Pierre Auger Observatory

**Surface Detector Electronics Upgrade
List of ECR
for UUB Version 3**

Abstract:
This document is the reference list of the ECR for the UUB Version 3

ECR 3:

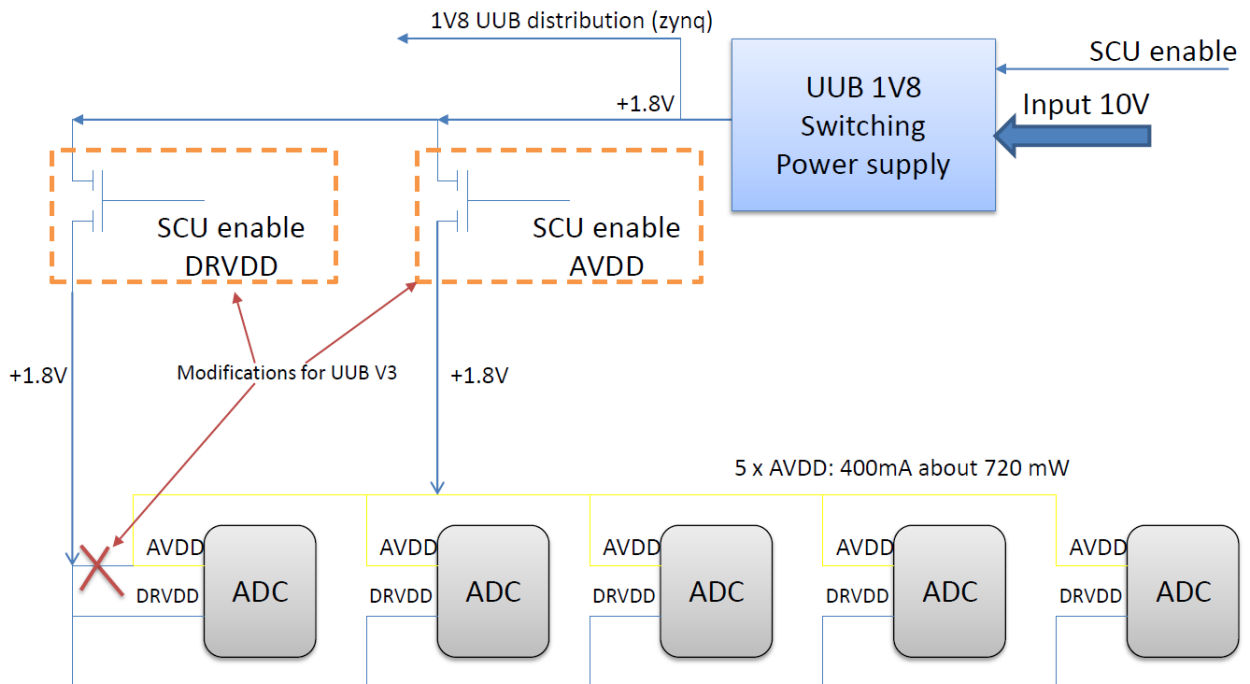
AD9628 power supply

Switch on/off by mosfet

ECRs 17 & 29:

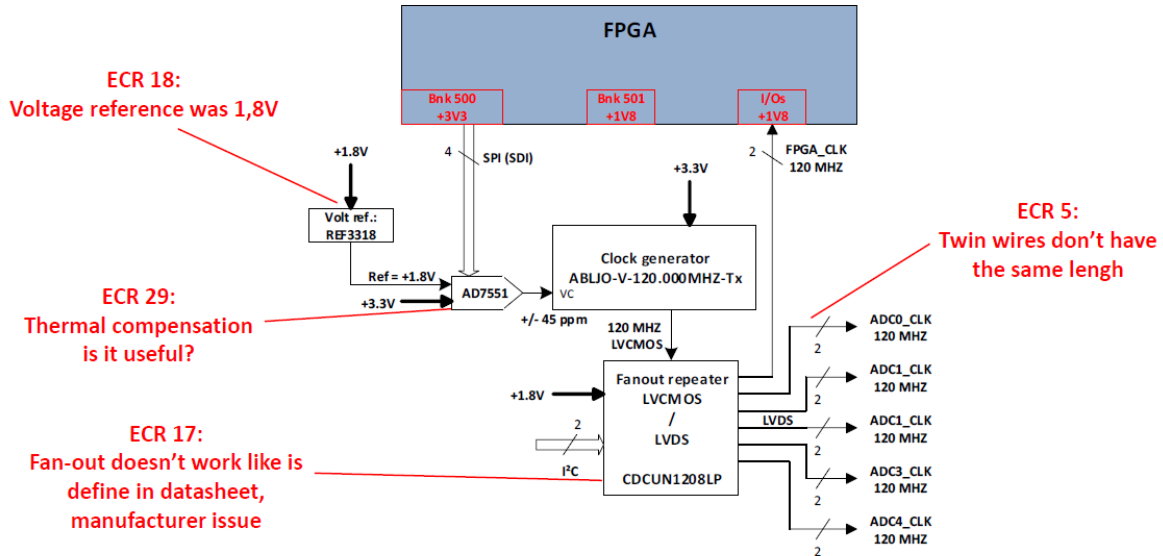
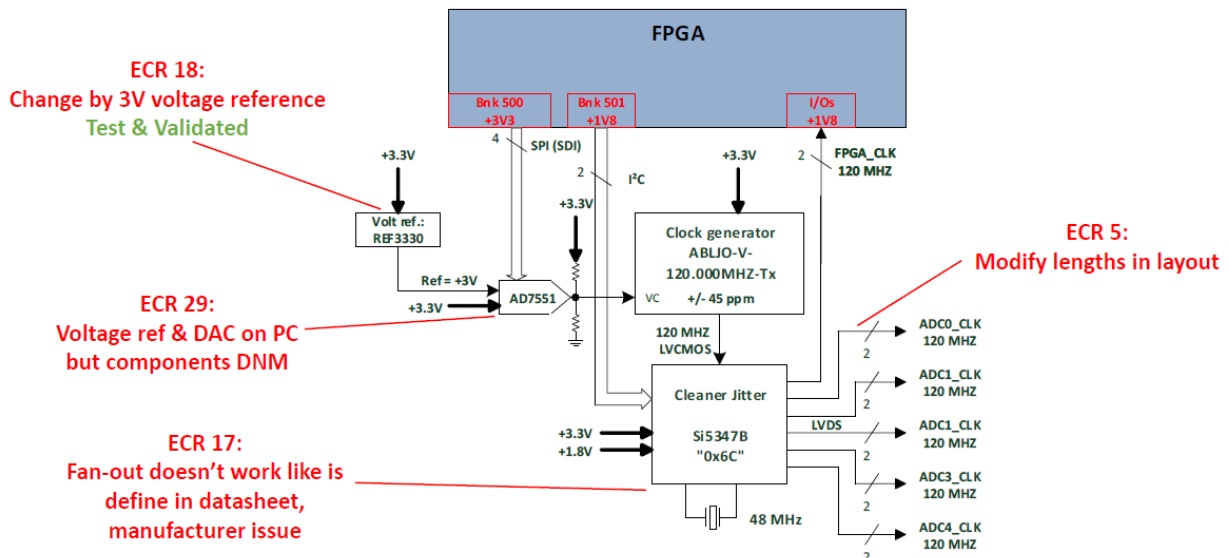
Present V2.0 Schematic:

Next V3.0 Schematic:

- The Fan-out is changed by a solution already test and validated: **Jitter Cleaner**
- Thermal frequency compensation useless: Time tagging function already integrated -/+ 45ppm tolerance

ECR 20:

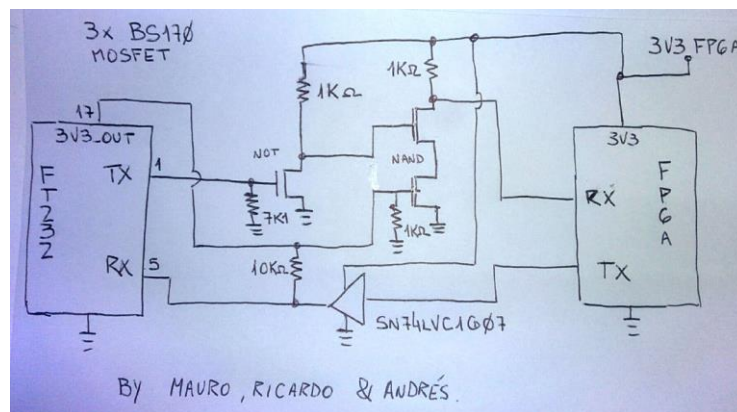
Buffer open-drain must be added for FPGA protection. VCCIO pin powered by UUB 3,3V, it's not enough.

ECR 44:

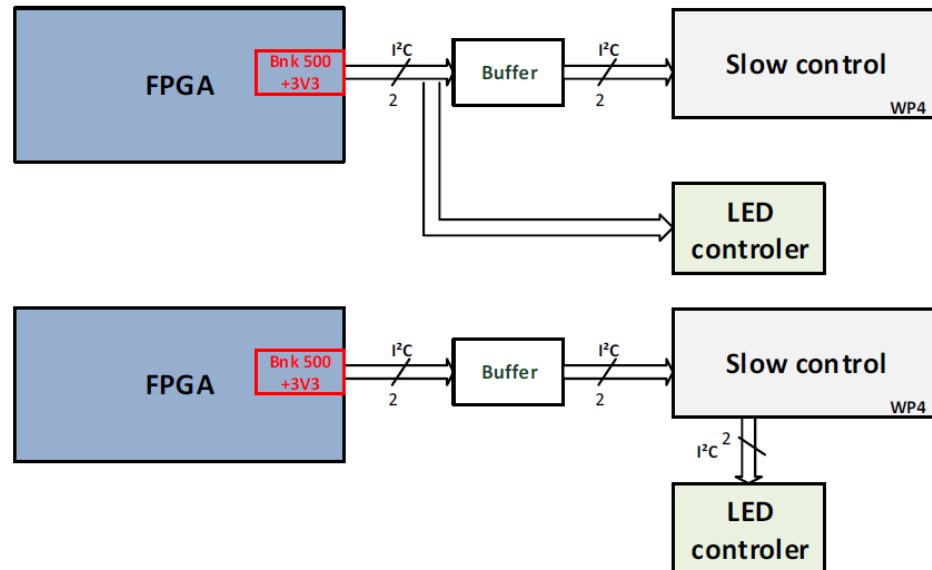
I²C communication with LED DAC problem generates Watchdog restarts the UUB

2 available channel in Slow-control could be used for LED-controller
